BFP-2 BACKFLOW PREVENTER

Shop Drawing Submittal Review

Project Name: Webster University-**ISB**

Copies	No.	Description
1 PDF	221119P02	(Submittal No.'s)
		(Cannon #22 1119-004) – (Paric #15051-) – (WES #607)
		• Domestic Water Piping Specialties

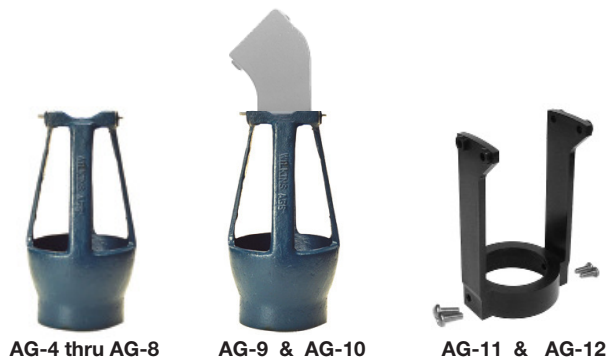
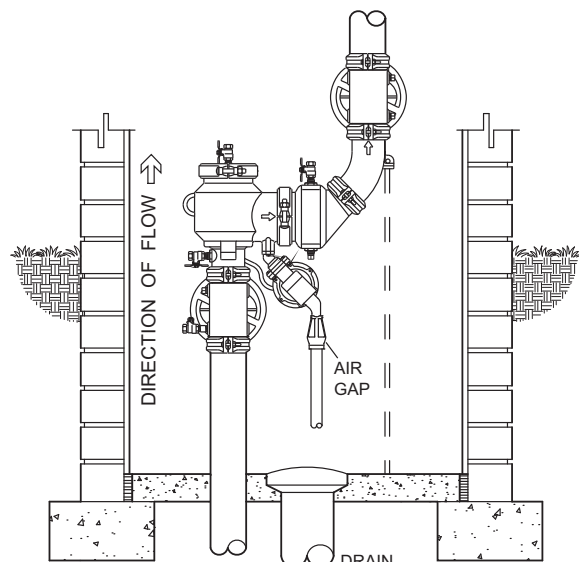
1. BFP-2 - Provide caps and tethers for each test cock.
